Attachment 1 - PLN17/0694 - 11 Brunswick Street, Fitzroy - UD advice DLA external

11 Brunswick Street, FITZROY Urban Design Referral

Date	28 th November 2017
Planning Scheme	Yarra
Council Reference	PLN17/0694
Proposal	Partial demolition and construction of an eight storey residential building

To: Lara Fiscalini
From: Artemis Bacani
Date: 22 November 2017
Subject: Application No: PLN17/0694
 Description: Mixed Use
 Site Address: 11 Brunswick Street, Fitzroy

Figure 1 – Rear form visibility in direct views from Brunswick Street above retained heritage façade, updated to include lift core and visibility above parapet (rather than pediment) (Source: CHC Architects, with emphasis added)

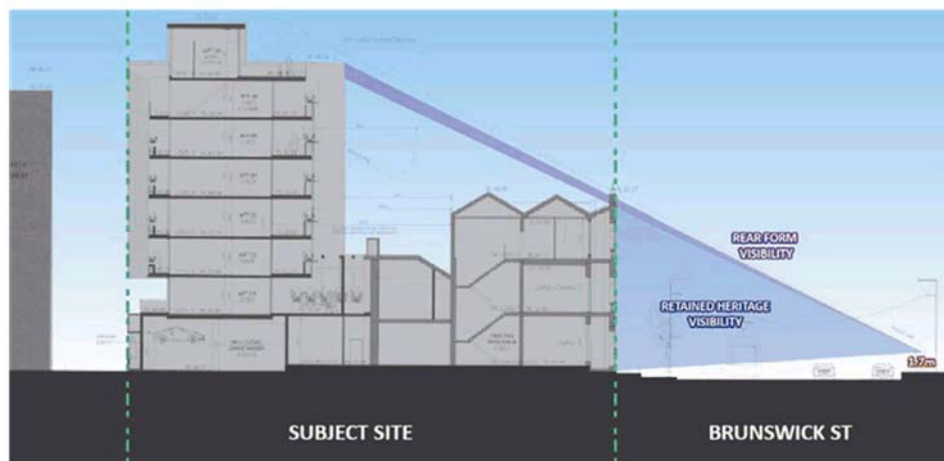
The dynamic between each extreme (transformative change and character retention) is already evident within Brunswick Street, which – where proximate to the subject site - generally comprises taller commercial and institutional built form (such as the ACU campus and St Vincent's Hospital) set back behind 2-3 storey high street walls (including intact heritage fabric). Recent approvals and proposals that we are aware of – including that at 44 Brunswick Street Fitzroy (5 storeys), as well as the current planning permit application for 11 storeys at 77 Victoria Parade – will only further reinforce this. In response, the proposal's fundamental design concept responds to the existing/emerging character of the southern portion of Brunswick Street through retention of existing on-site heritage fabric to Brunswick Street (which will perpetuate the subject site's existing streetscape contribution and height) and the massing of contemporary rear form behind – which will read as both visually recessive (in direct views above the retained heritage parapet) and sufficiently distinct (in longer range oblique views). Refer below. This is supported.

Diagram 1

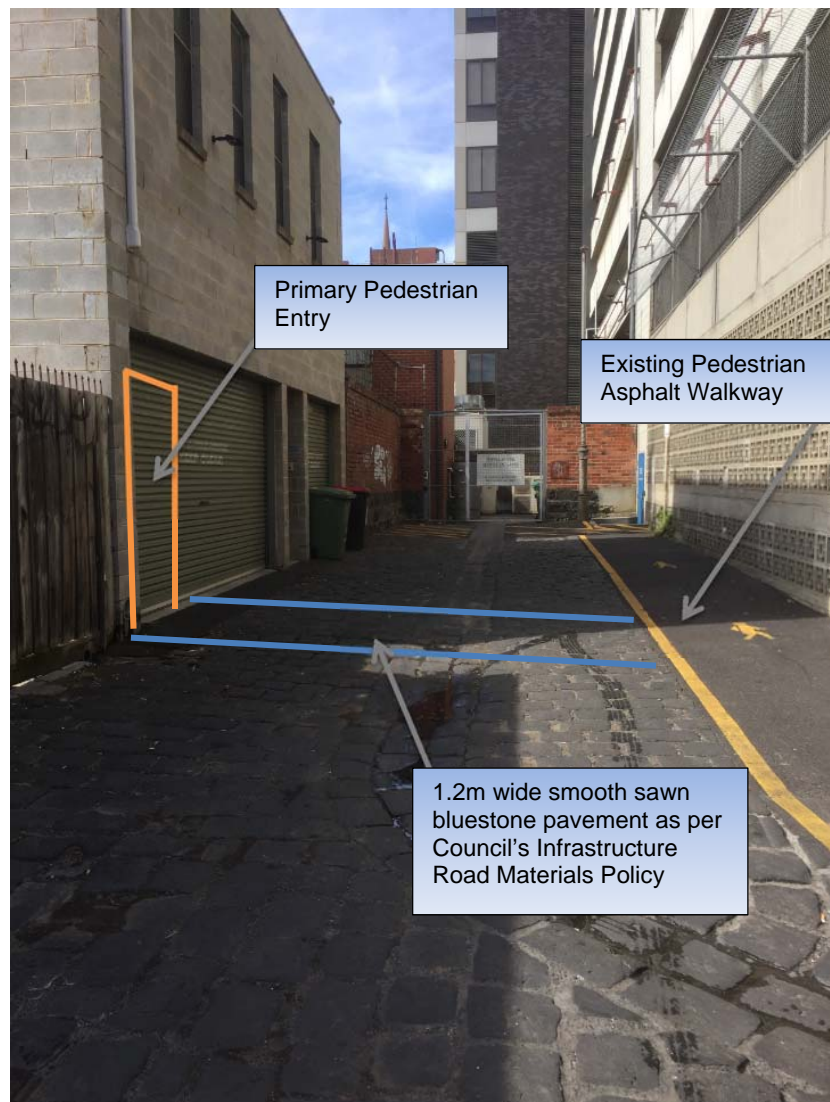
To further improve the link between the site's primary pedestrian entry to the existing asphalt walkway, the applicant would be required to construct a 1.2 to 1.8 metre wide smooth bluestone pavement from the main pedestrian entrance to the existing asphalt walkway along the west side of the Right of Way as shown on Diagram 1 below.
